UNITED STATES PATENT AND TRADEMARK OFFICE

APPLICATION NO.	FILING DATE	FIRST NAMED INVENTOR	ATTORNEY DOCKET NO.	CONFIRMATION NO.
10/773,573	02/09/2004	Tsutomu Kojima	P21-164404M/ISI	3561

Office Action Summary	Application No.	Applicant(s)	
	10/773,573	KOJIMA ET AL.	
	Examiner	Art Unit	
	Joshua T. Kennedy	3679

DETAILED ACTION

Examiner's Figure

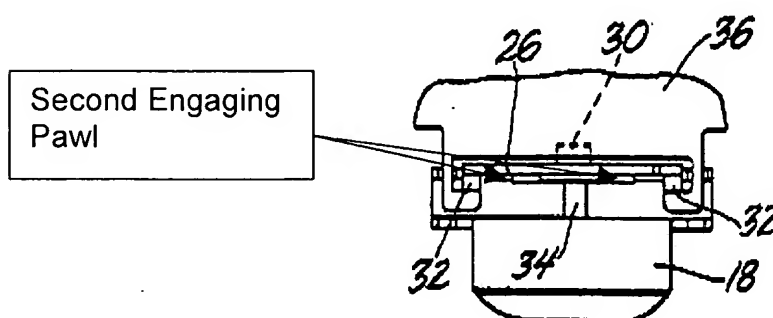
"The spring blade that is disclosed by the Bakker et al. reference corresponds to both the claimed engagement wall and the claimed second engaging pawl."

Examiner respectfully disagrees and points to the Examiners figure below which particularly points out the second engaging pawl which extends downwardly from portion 26 and opposes the first engaging pawl (34).
